# City of Sandy

**Planning Commission Meeting**  
**Meeting Location:** Hybrid - 39250 Pioneer Blvd. and Zoom  
**Meeting Date:** Monday, April 24, 2023  
**Meeting Time:** 6:30 PM

- 7.1. 22-031 DR/VAR/TREE State Street Homes Mixed-Use Development 12 - 302  
[22-031 DR/VAR/TREE State Street Homes Mixed-Use Development - Pdf](#)  
[Exhibit A Land Use Applications](#)  
[Exhibit B Narrative](#)  
[Exhibit C Plan Set](#)  
[Exhibit D and E Lighting Plans and Cut-Sheets](#)  
[Exhibit F Stormwater Report](#)  
[Exhibit G Transportation Analysis Letter](#)  
[Exhibit H Arborist Report](#)  
[Exhibit I ODOT Memo](#)  
[Exhibit J Indenture of Access](#)  
[Exhibit K and L Easements](#)  
[Exhibit M Parks Comments](#)  
[Exhibit N Fire Marshal Comments](#)  
[Exhibit O ODOT comments](#)  
[Exhibit P City Transportation Engineer DKS Comments](#)  
[Exhibit Q PW Comments](#)  
[Exhibit R Third Party Arborist Review](#)  
[Exhibit S ODOT Comments State Street Homes pre-app](#)  
[Exhibit T Email from ODOT](#)  
[Exhibit U Sandy Multi-Family Site Plan Revisions \(rcvd Feb 9, 2023\)](#)  
[Exhibit V Dennis Petross Public Comments \(received February 14 2023\)](#)

**ENTRY UTILITY PLAN**  
 MIXED USE SITE DEVELOPMENT  
 38015 HWY 26, SANDY, OR 97055

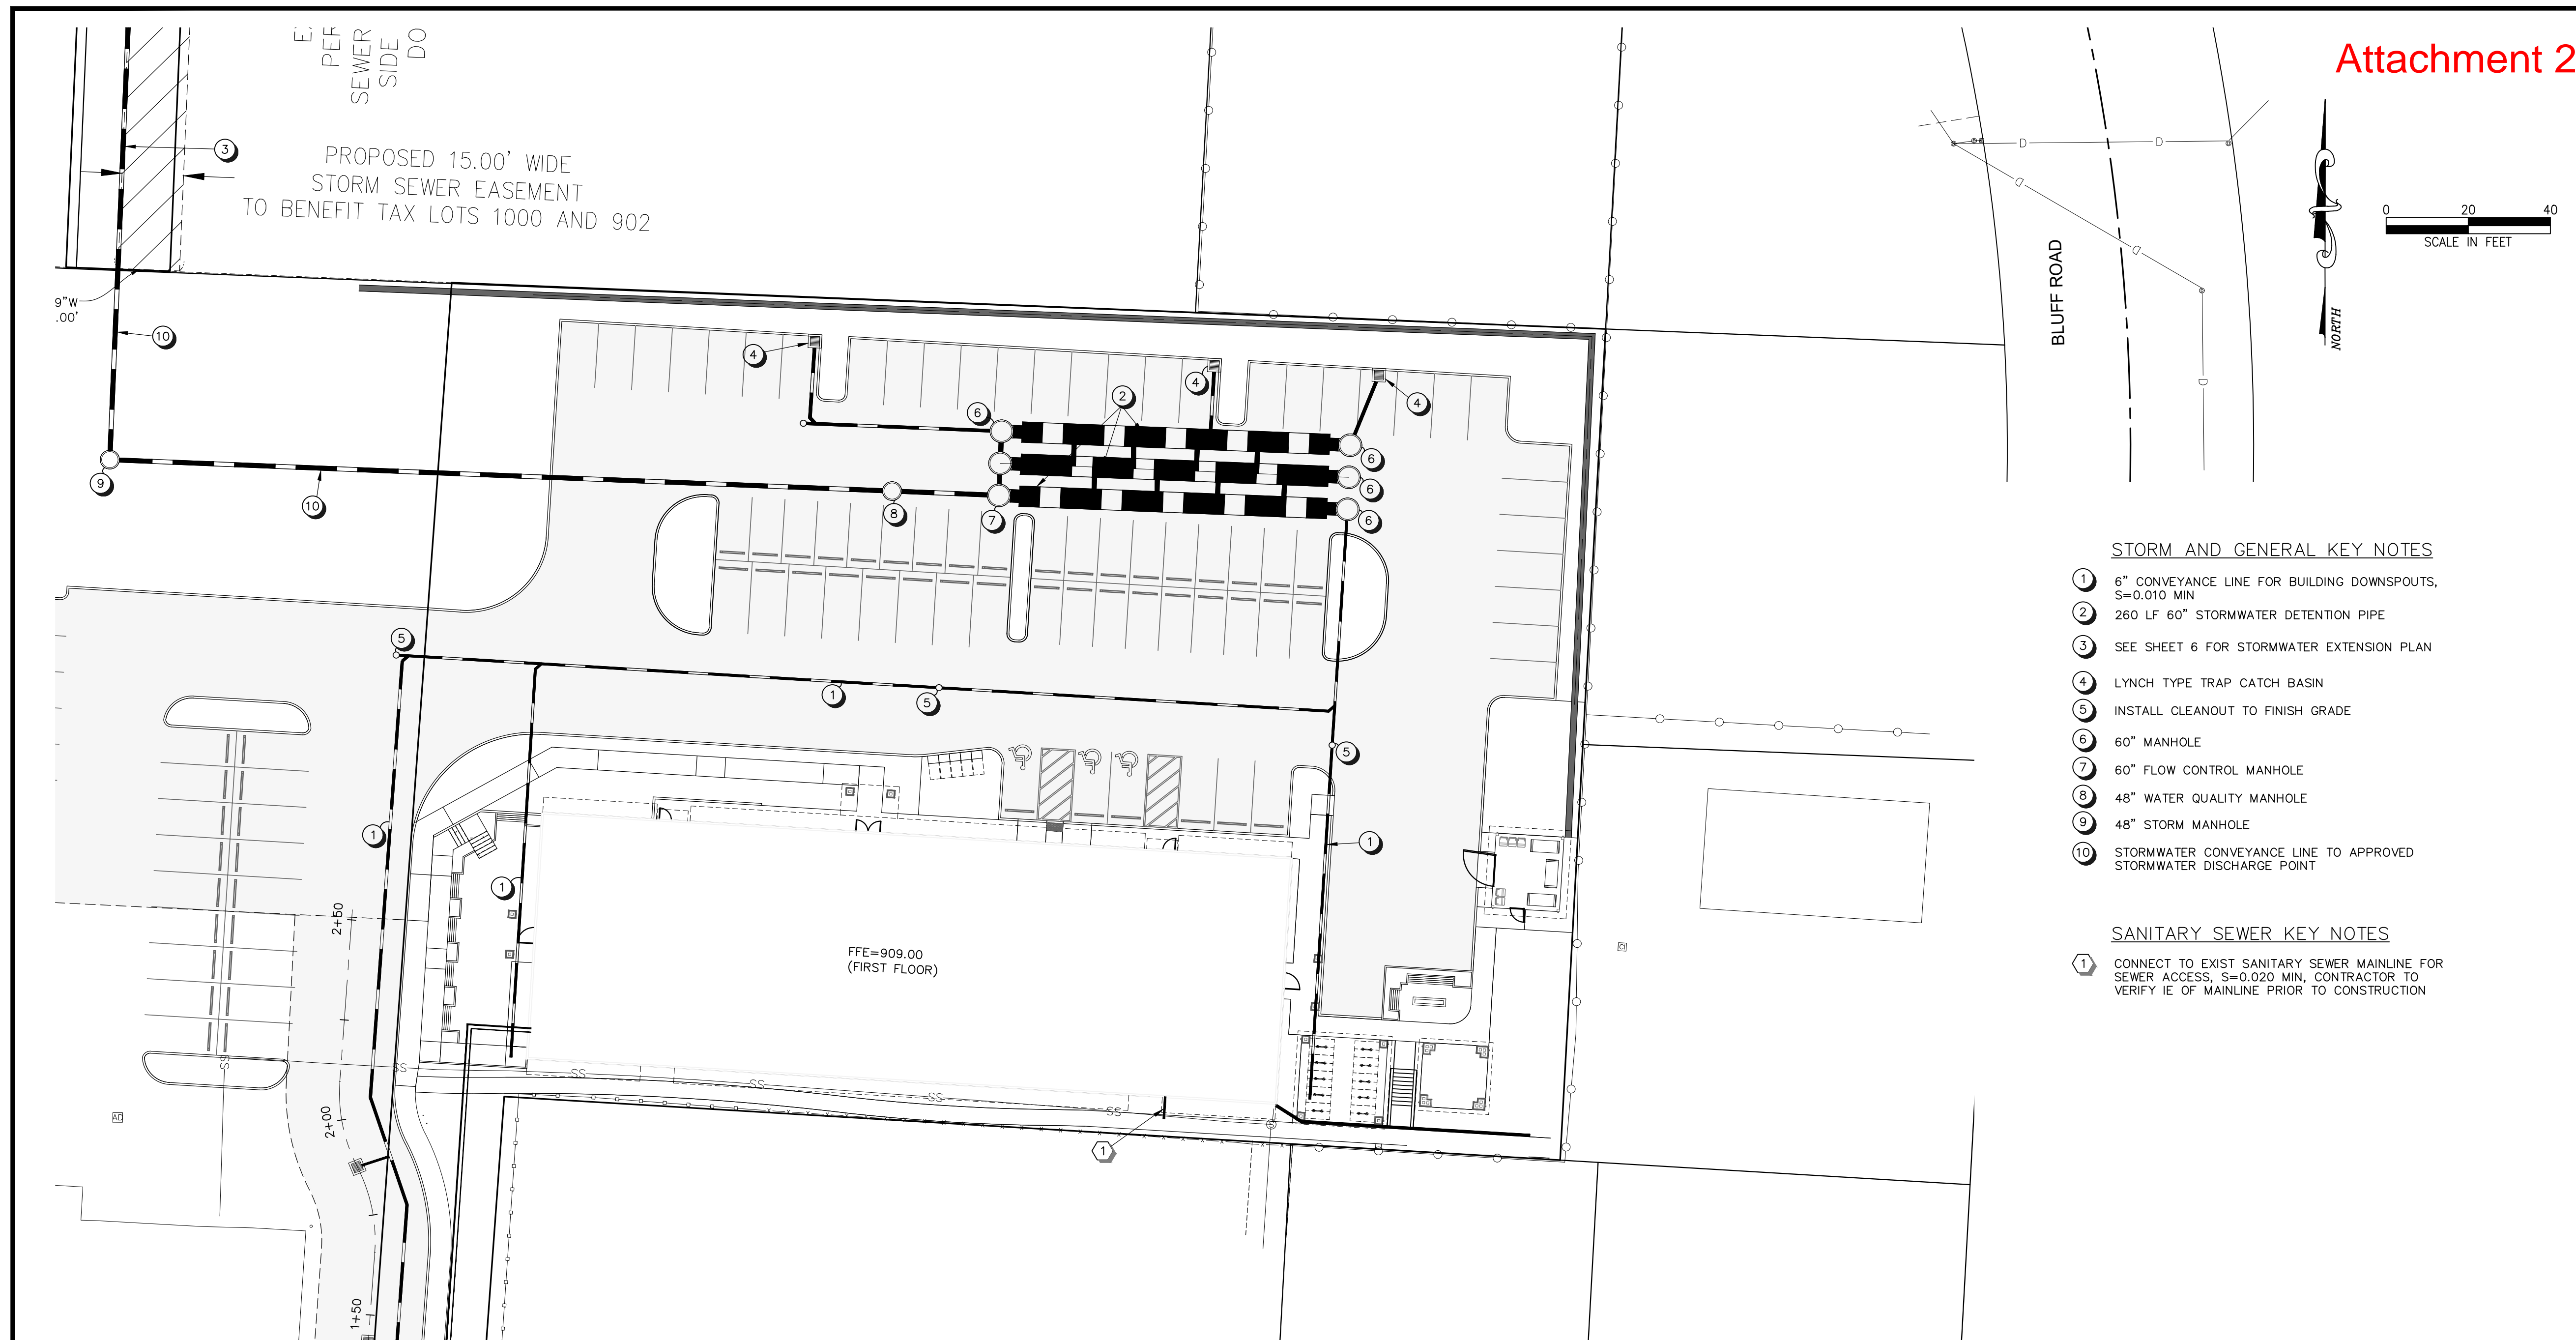
~~91.~~101. Section 17.84.60 outlines the requirements of public facility extensions. The applicant submitted an Entry Utility Plan (Exhibit C, Sheet 4) and a Site Utility Plan (Exhibit C, Sheet 5) that show the location of proposed water, sanitary sewer, and stormwater drainage facilities for Tax Los 902 and 1000.

**COMPOSITE SITE PLAN**  
MIXED USE SITE DEVELOPMENT  
38015 HWY 26, SANDY, OR 97055

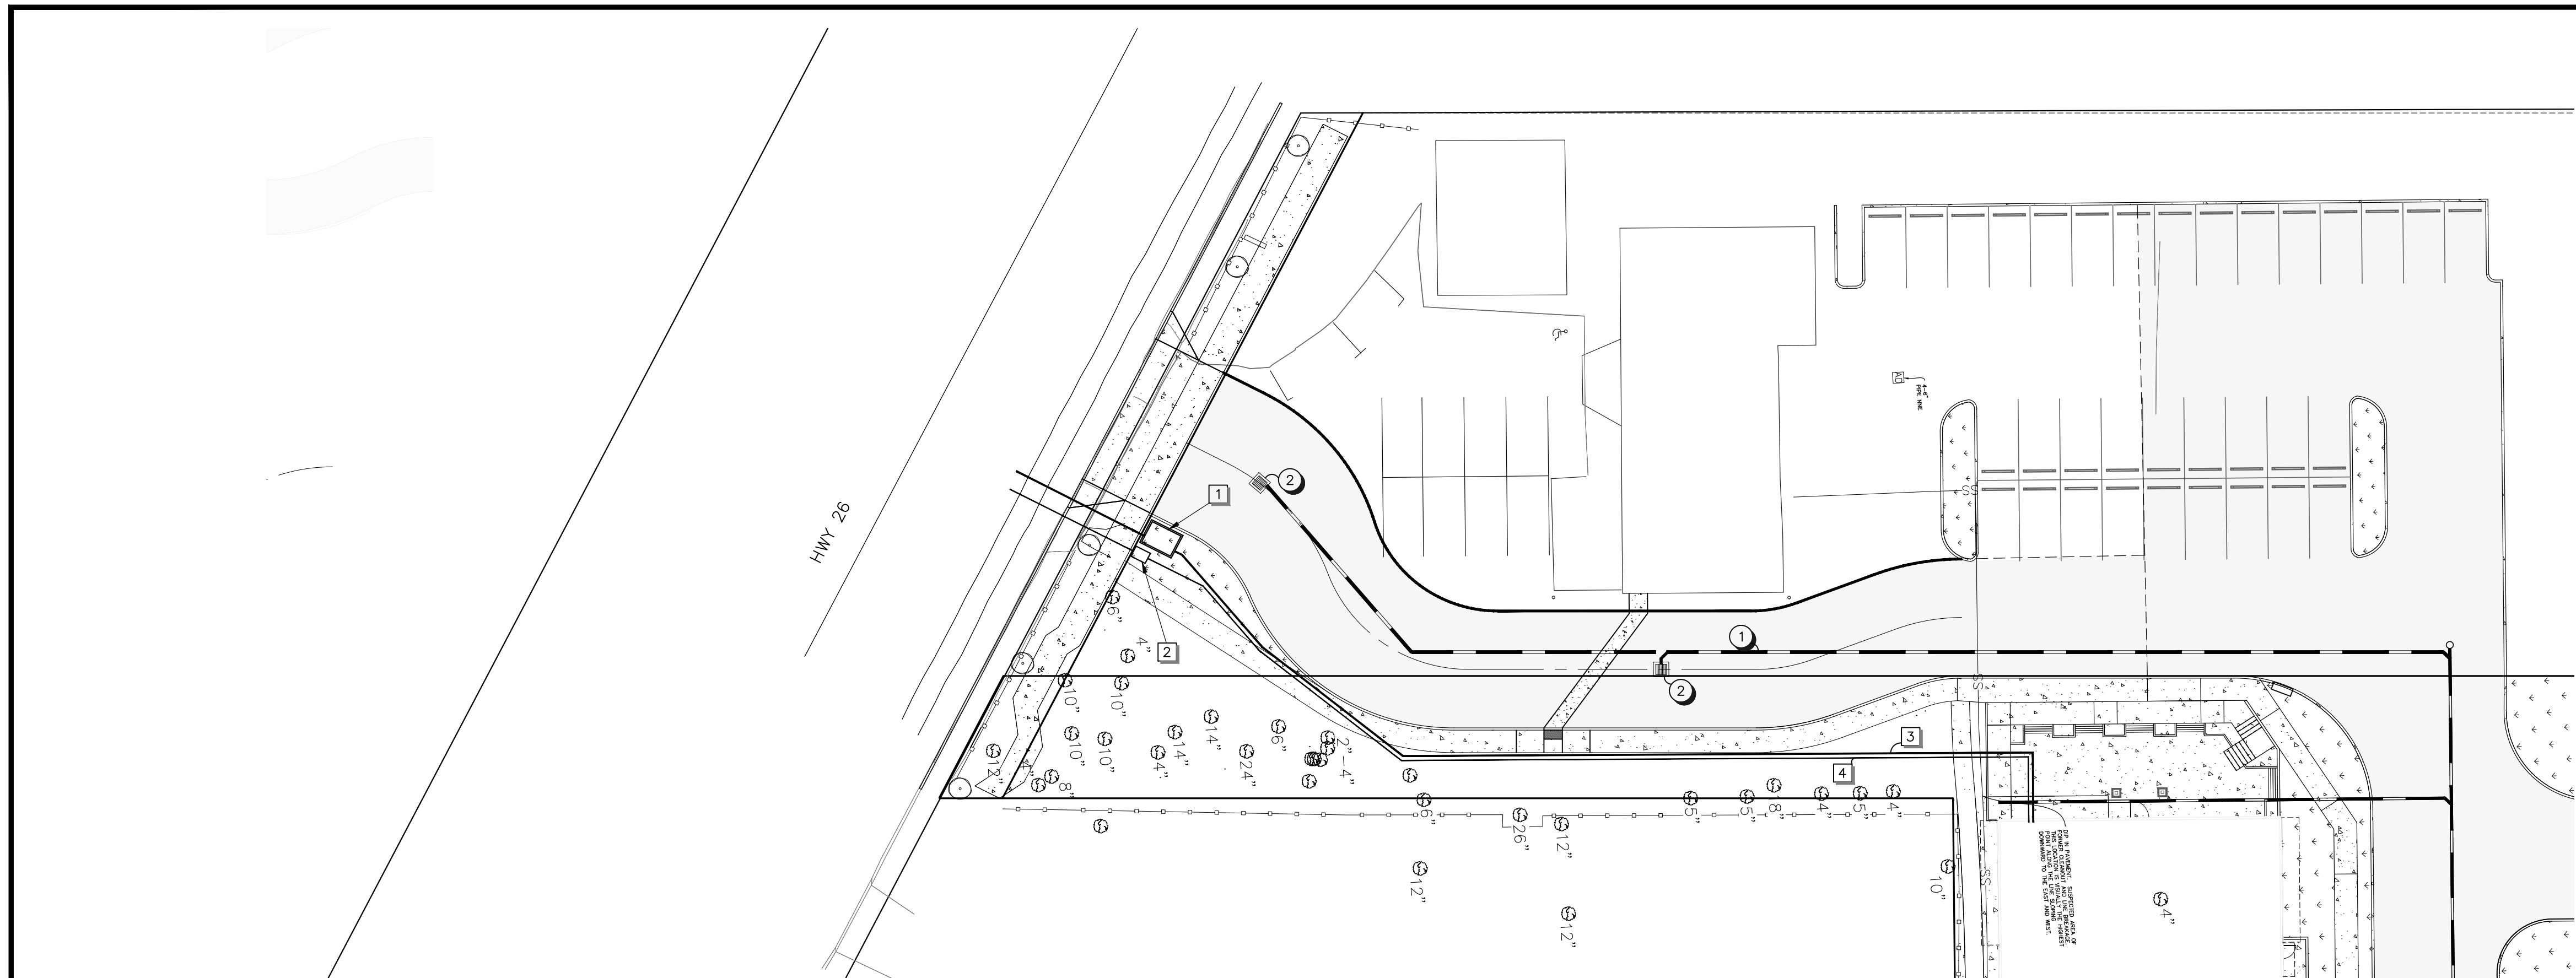
Highway 26. The Site Plan (Exhibit ~~Y~~C, Sheet 3) details a pedestrian walkway along the ~~pole portion of the lot~~east side of the shared driveway that connects the sidewalk on Highway 26 to the proposed mixed-use building entrance. The Site Plan also details a 4-foot-wide colored concrete inlay pedestrian walkway that connects the pedestrian walkway across the shared driveway aisle to the Paola's Pizza Barn entrance in compliance with Sections 17.90.120(A.5 and A.7). ~~The proposal also includes a reconfiguration of the existing parking areas on the Paola's Pizza Barn site (Tax Lot 1000). Currently, there are existing parking spaces for the Paola's Pizza Barn located in the flagpole portion of Tax Lot 902 with a striped walkway connecting the spaces to the Paola's Pizza Barn building. The proposed reconfiguration will remove these spaces and the striped walkway. The parking spaces located within the flagpole will be replaced with the relocated shared access driveway and pedestrian walkway connecting the sidewalk on Highway 26 to the mixed-use building.~~ **The applicant shall update the Plan Set to detail a colored concrete inlay crosswalk connecting the pedestrian walkway located in the flagpole of Tax Lot 902 across the shared driveway aisle to the Paola's Pizza Barn entrance in compliance with the design standards of Section 17.90.120(A.5 and 7). The pedestrian crossing shall have a paved delineation in the form of a colored concrete inlay.**

~~56.61.~~ Staff believes the requested variance to Section 17.74.40(B.2) to exceed the 4-foot maximum height of a retaining wall and fence in a commercial front yard meets Criterion A. As detailed on the Composite Site Plan (Exhibit Y~~C~~, Sheet 3) and the Grading and ESC Plan (Exhibit Y~~C~~, Sheet 7), the applicant is proposing ~~an~~ a retaining wall with a maximum height of 5 feet ~~approximately 5-foot to 7-foot tall retaining wall~~ on the south side (front) of Tax Lot 902 south of the proposed bicycle parking enclosure, stairs, and gazebo. ~~The Site Plan~~

PRELIMINARY  
 PLANTING  
 PLAN

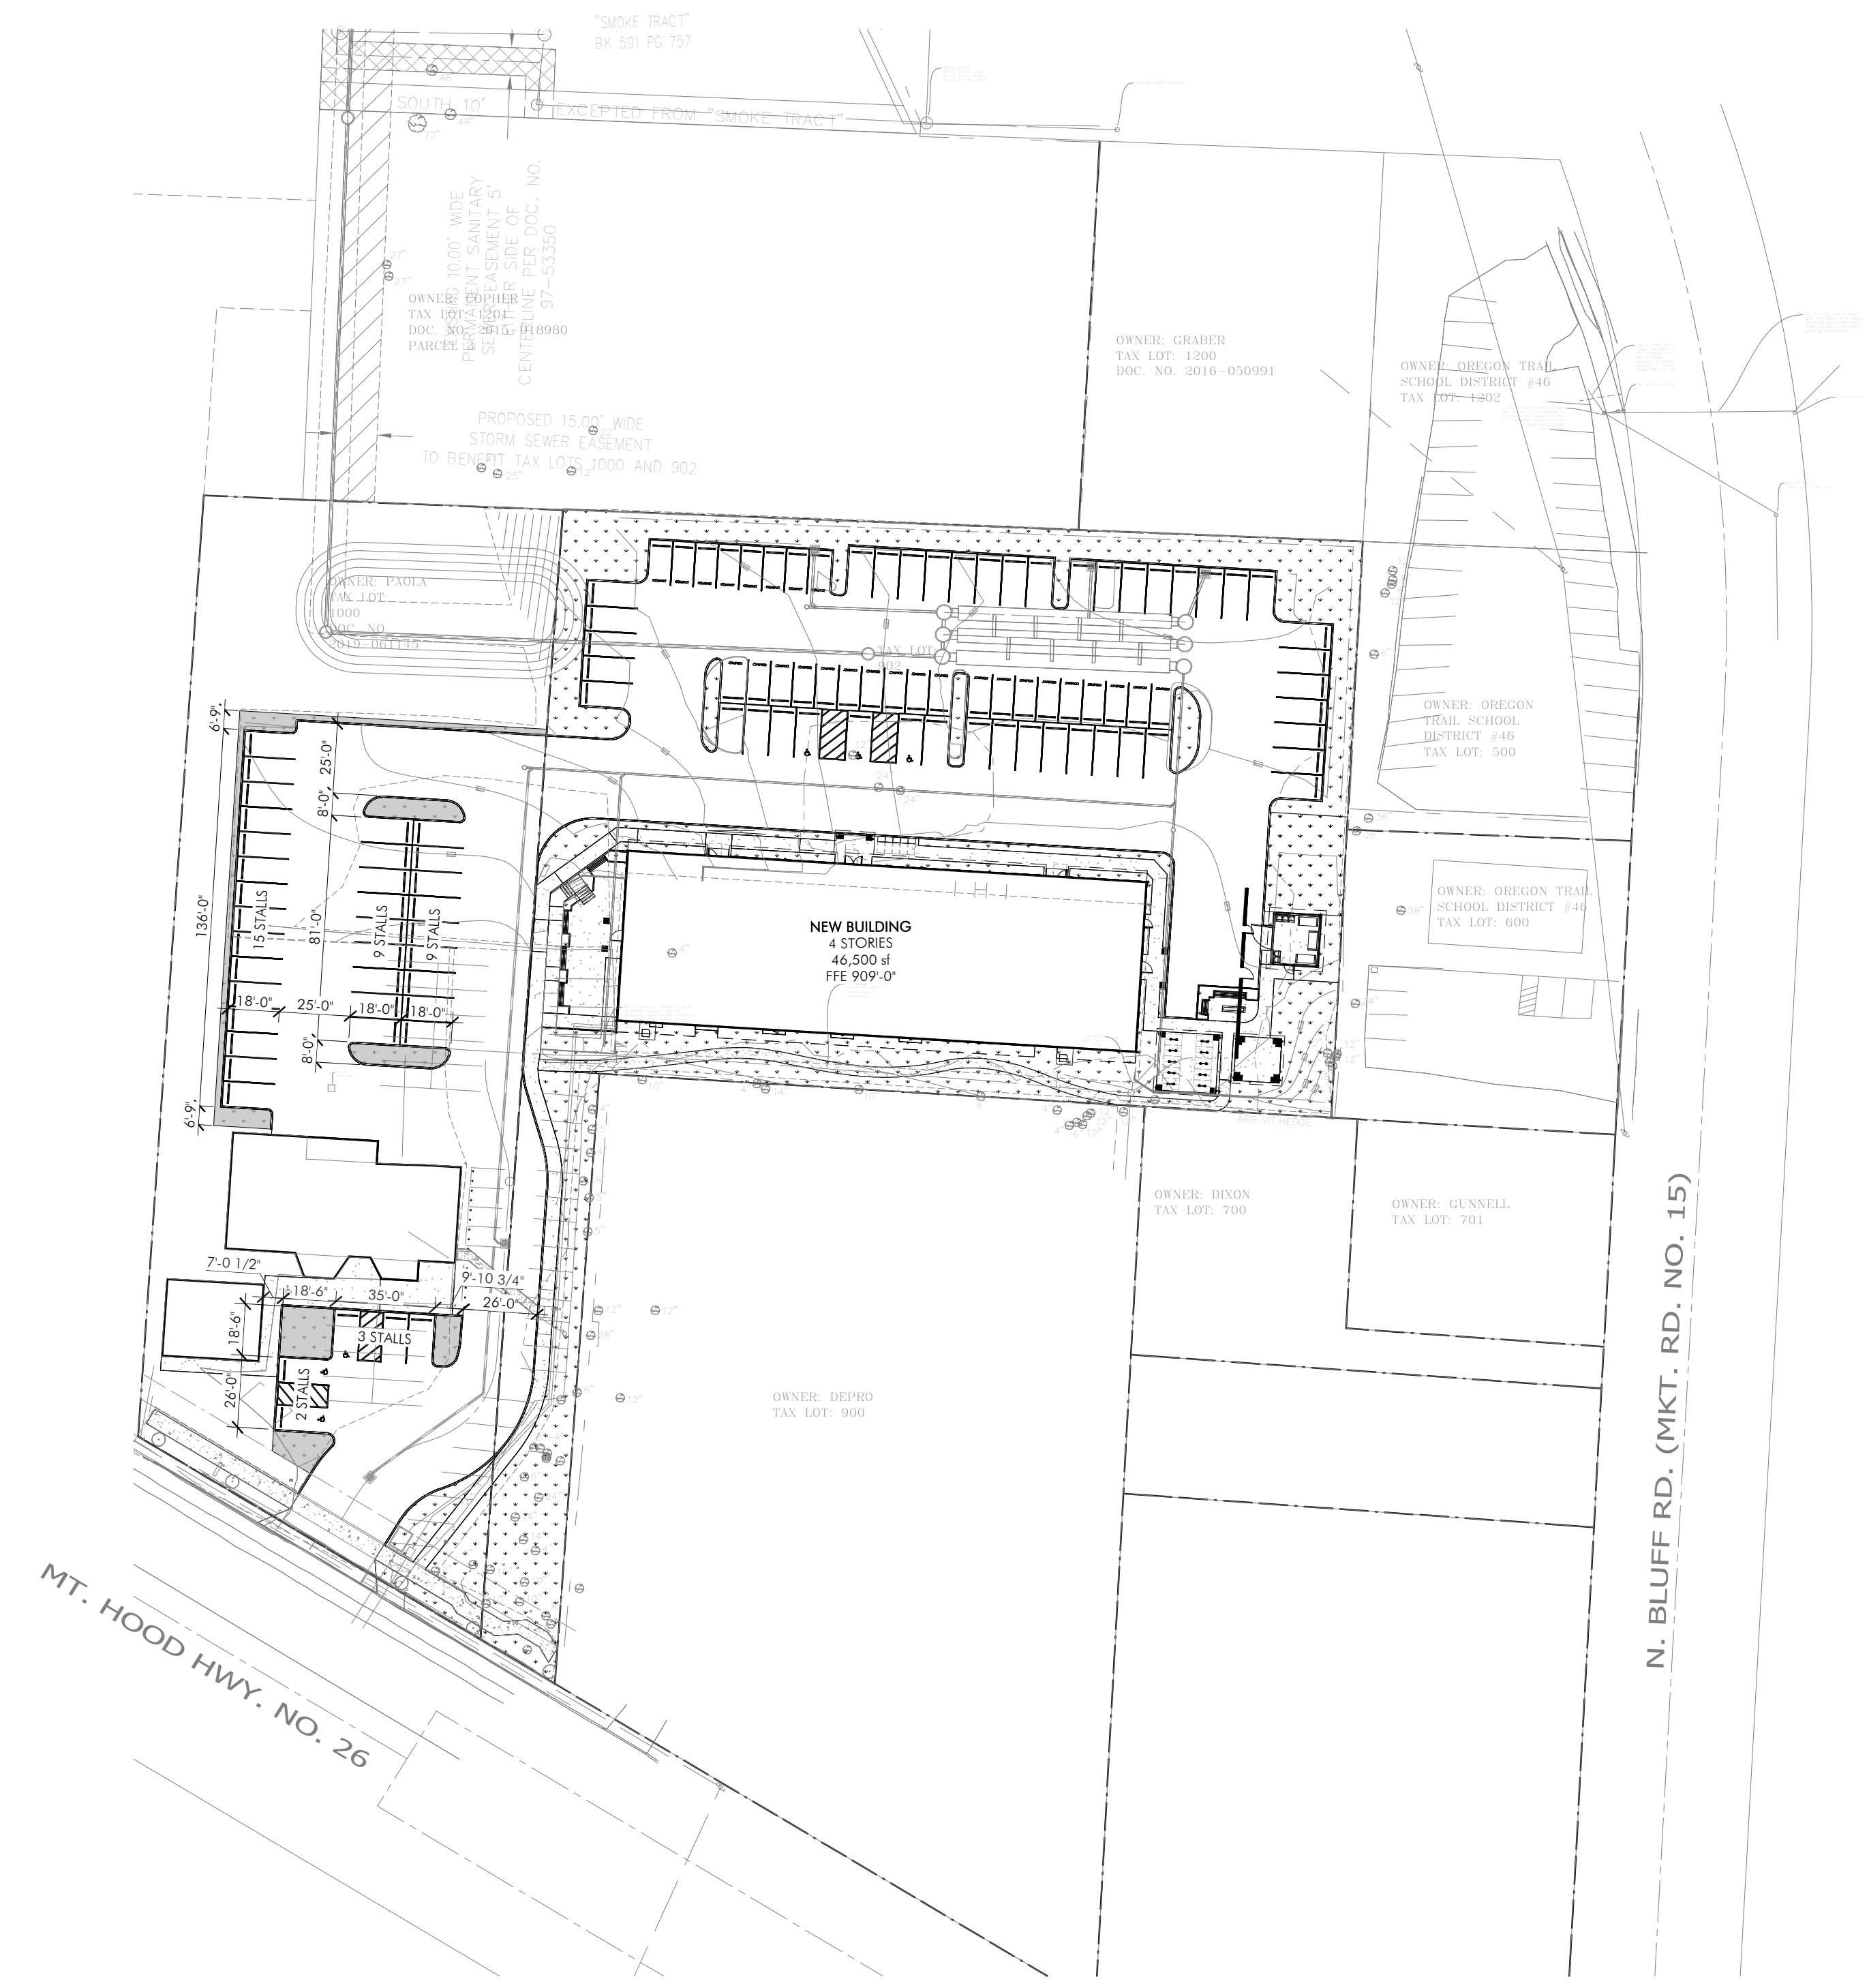
~~Neither the Enlarged Site Plan (Exhibit Y, Sheet A1.01) nor~~ and the Preliminary Planting Plan (Exhibit Y, Sheet L2.1) detail a landscaping buffer along the west side of the newly configured parking area behind the Paola's Pizza Barn on Tax Lot 1000 at 2-feet in width that is proposed to be planted with a single groundcover (kinnikinick). **The applicant shall update the Preliminary Planting Plan Set to detail a minimum 5-foot-wide (interior dimension) landscape planter with a mix of low-lying ground cover and shrubs, and vertical shrubs and trees between the proposed westernmost parking row on Tax Lot 1000 and the property to the west.**

large trees and four (4) small trees in the parking area of Tax Lot 902. Tax Lot 1000 contains approximately 4437 parking spaces, which requires a minimum of 6-5 medium sized parking lot trees. The Preliminary Planting Plan (Exhibit Y, Sheet L2.1) details planting 2-4 medium sized parking lot trees in the rear parking area and three (3) medium sized trees in the front parking area on Tax Lot 1000 in compliance with the code. ~~However, as previously stated, in order to be in compliance with Section 17.98.120(D), the applicant shall update the Preliminary Planting Plan to detail one major structural tree and ground cover in the landscape planters at each end of each parking bay. This will require a reconfiguration of the parking in front (south) of the existing Paola's Pizza Barn building.~~ The updated Composite Site Plan (Exhibit Y, Sheet 3) details the proposed frontage improvements along Highway 26, including the 10 foot wide planter strip with street trees placed approximately 30 feet on center and located in the northern 5 feet of the planter strip to minimize conflict with overhead powerlines. The Preliminary Planting Plan (Exhibit Y, Sheet L2.1) does not reflect the updated frontage improvements nor does it detail proposed street trees. **The applicant shall update the Preliminary Planting Plan to detail the required frontage improvements, including street trees, and the planting palette shall indicate the street tree species. If the 10-foot-wide planting strip provides insufficient space to set back the street trees such that they won't grow into the power lines, the applicant shall select short growth species to avoid conflict with overhead utilities.**

5. Submit an updated Preliminary Planting Plan to detail the following:
  - a. A minimum 5-foot-wide (interior dimension) landscape planter with a mix of low-lying ground cover and shrubs, and vertical shrubs and trees between the proposed westernmost parking row on Tax Lot 1000 and the property to the west. The revised plan (Exhibit Y, Sheet L2.1) details this landscape planter at only 2 feet in width.
